Access Compliance Report

Public Rights-of-Way

(Pedestrian Signals)

Intersection ID: N/A	Main Street:	Cross Street: N/A	Location: N/A
ADA ID: C1B04A5A7E41	Signal Type: One Push Button-Non APS	Overall Compliance: No	Severity Score: BTN 1: N/A BTN 2: N/A No BTN: N/A
Codes/Mitigation Info/Possible Solution		Field Measurements/Component Compliance

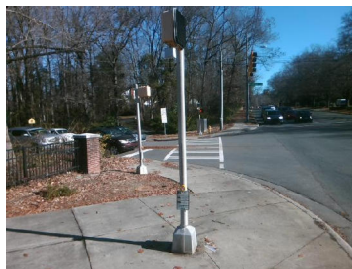
PROW/ADA: TMUTCD 4e.08, R404.2

Yes	B 1 Clear Xing Direction?	ClearlyMarked	N/A	B 2 Clear Xing Direction?	N/A
	B 1 Crossing Direction	To SE		B 2 Crossing Direction	N/A
Yes	B 1 DistanceTo XWalk (in)	0.0	N/A	B 2 DistanceTo XWalk (in)	N/A
No	B 1 DistanceTo Curb (in)	104.0	N/A	B 2 DistanceTo Curb (in)	N/A
Yes	B 1 Diameter (in)	2.0	N/A	B 2 Diameter (in)	N/A

Possible Solutions: Replace Signal Push Button With APS Button on New Post. Remove & Relocate Sign.
